Subject: Cottonwood Sand Mining Project Environmental Impact Report Issued 12/16/21
(PDS2018-MUP-18-023), (PDS2018-RP-18-001); LOG NO. PDS2018-ER-18-19-007;
SCH# 2019100513

The purpose of this response is to provide specific comments regarding the Cottonwood Sand Mining Project Draft Environmental Impact Report (draft EIR). For the reasons discussed below, the Project draft EIR is a flawed and incomplete document that does not adequately analyze the significant environmental impacts of the potential sand mine project to the people, wildlife, water, air, and roads of the community. Additionally, the Project does not propose adequate mitigation measures or alternatives to address those impacts. The draft EIR does not comply with applicable goals, policies or requirements of the San Diego County General Plan as well as the Valle De Oro Community Plan.

D-O10 – StopCottonwoodSandMine.org

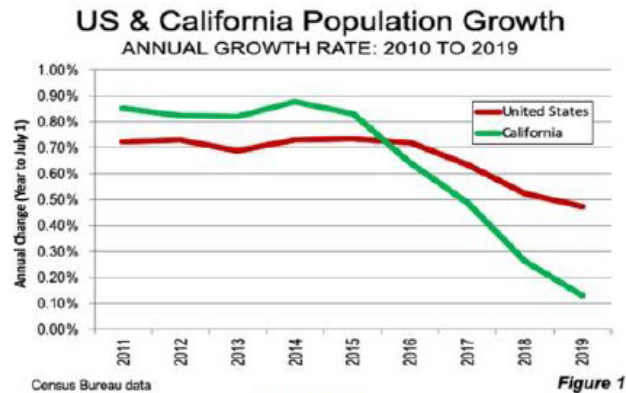
The draft EIR compares Vehicle Miles Traveled (VMT) for this Project with the County demand for sand and related import of sand and its relative VMT. This is not an appropriate comparison to show that the VMT and subsequent Green House Gas Emissions will have a less than significant impact to the community and its surrounding uses simply because it is less than potential County-wide VMT and GHG.

Mitigation for this proposed project must show a plan onsite, not County-wide. The draft EIR must be revised to describe appropriate mitigation related to VMT.

D-O10-62 Please see Topical Response 8 regarding VMT analysis. GHG impacts were found to be less than significant, thus requiring no mitigation. It is also important to note that the GHG analysis did not rely on the potential reduction in regional VMT the Project may achieve.

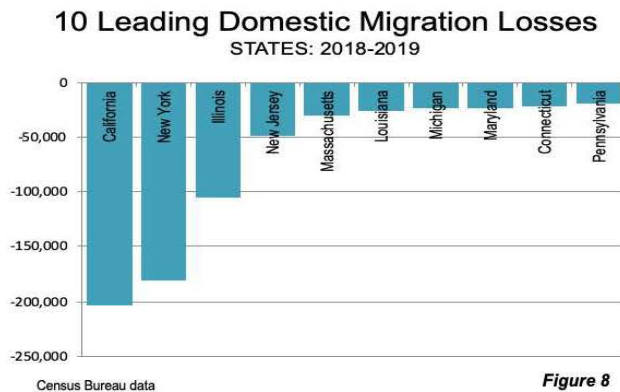
The perceived need for aggregate was based upon what was a steadily growing population in San Diego County as well as California. However, the California population is

stagnated and expected to decline; as evidenced by the recent loss of a Congressional Seat in the House of Representatives. See above census bureau data charts. Therefore, the need is not nearly as great as had been previously projected. Also, the remaining population is moving further from the coastal areas, including San Diego.

D-O10-63 The comment states that the aggregate demand was based on a growing population, but census bureau data shows stagnation and claims it is expected to decline. The data the comment shows include population growth data for all of California, not San Diego specifically, and is therefore not directly applicable to the aggregate demand projected for the County.
